**CONTRACT DOCUMENTS  
BOONE COUNTY, MISSOURI**

BID NO: 66-14DEC04 – Crushed Stone Aggregate and Chip Seal Products Term and Supply

**ADDENDUM #1**  
**(Issued December 2, 2004)**

ATTACHMENT 'B'

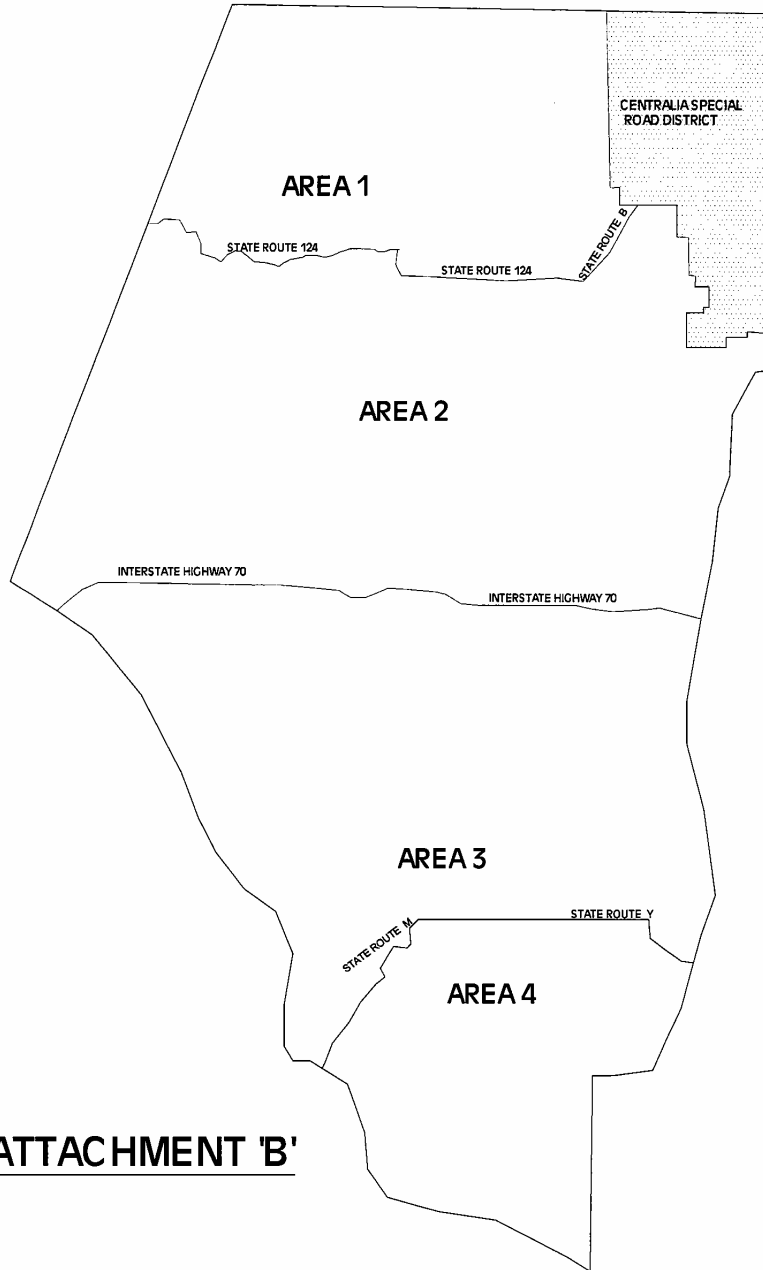
**Replace Attachment B with the attached Attachment B**

The revised Attachment B deletes the "points" in each area.
